DRAWING NO. 1 A.
SCALE 8 1/2" TO 1". DETAILS
FROM PLANS AT CAMDEN
PUBLIC HEALTH DEPT. AND FROM
SURVEY ON SITE. MARCH 1970.

NO 9 THE MOUNT HAMPSTEAD N.W.3
PROPOSED REBUILDING OF EXISTING DELAPIDATED GARAGE AND EXTENDING TO DOUBLE
WIDTH AND TO OPEN UP ORIGINAL ACCESS STAIRS.

NO 9 THE MOUNT HAMPSTEAD N.W.3.

ADDENDUM TO PLAN NO. 1. SUBMITTED TO
 SHED IN FURTHER DETAIL FRONT
 ELEVATION TO ROAD AND TREATMENT
 TO CONCEAL UNSIGHTLY LINTOL.

PLAN AT STREET LEVEL AS PROPOSED

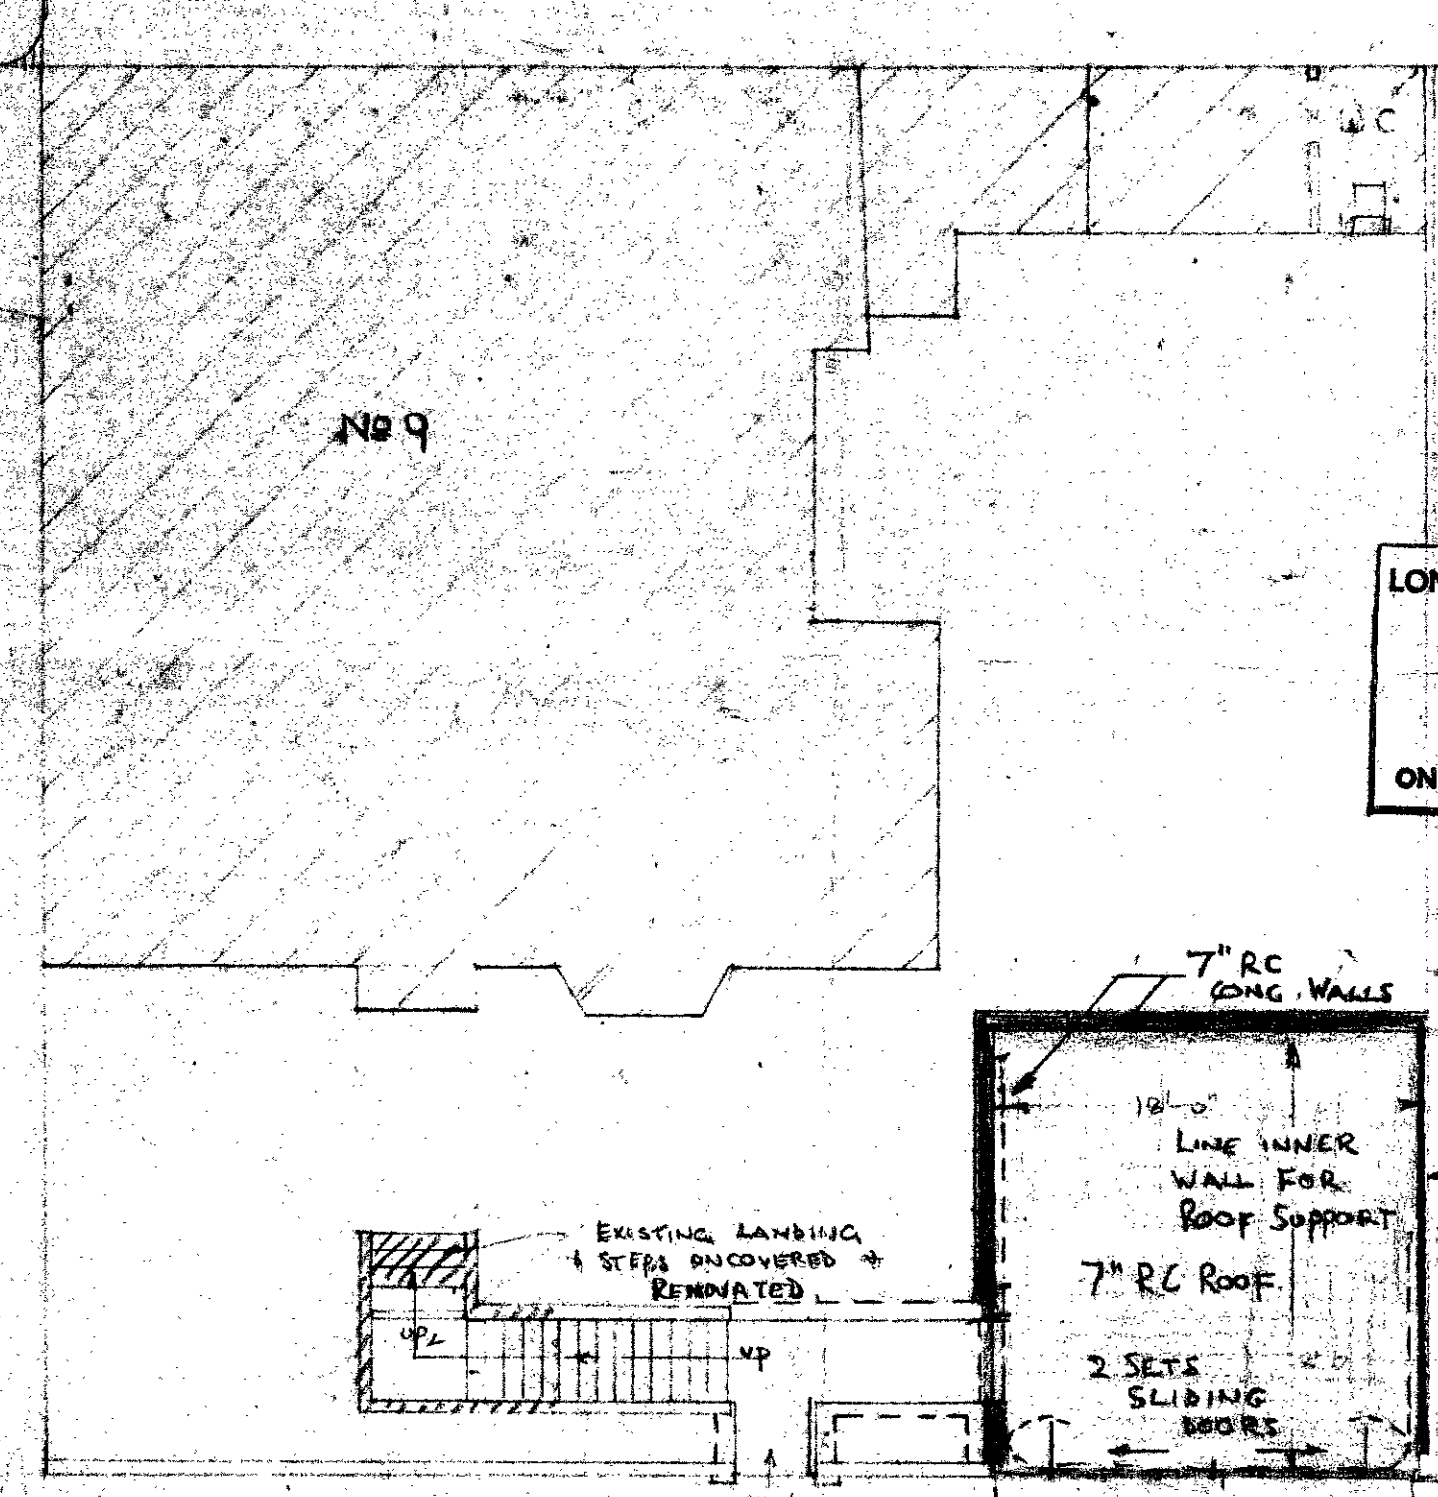
LINE EXISTING 15" WALL INSIDE WITH BRICK OR R.C. TO REQUIREMENTS OF DISTRICT SURVEYOR ALSO CALCULATIONS FOR R.C. WALLS + ROOF TO SUIT D/S.
